WARC TX MODIFICATION

To enable the FT-707 to transmit on the newly allocated amateur bands, the following modifications are required.

Figure 3-13A

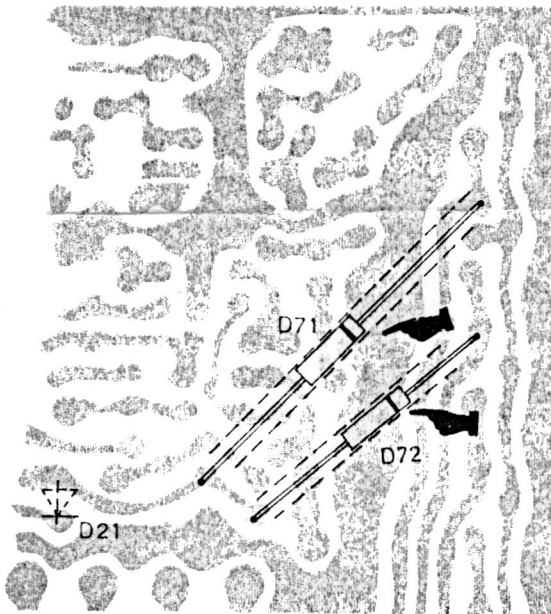
Refer to Figures below. Locate the RF UNIT, and remove diodes D₂₁, D₇₁ and D₇₂.
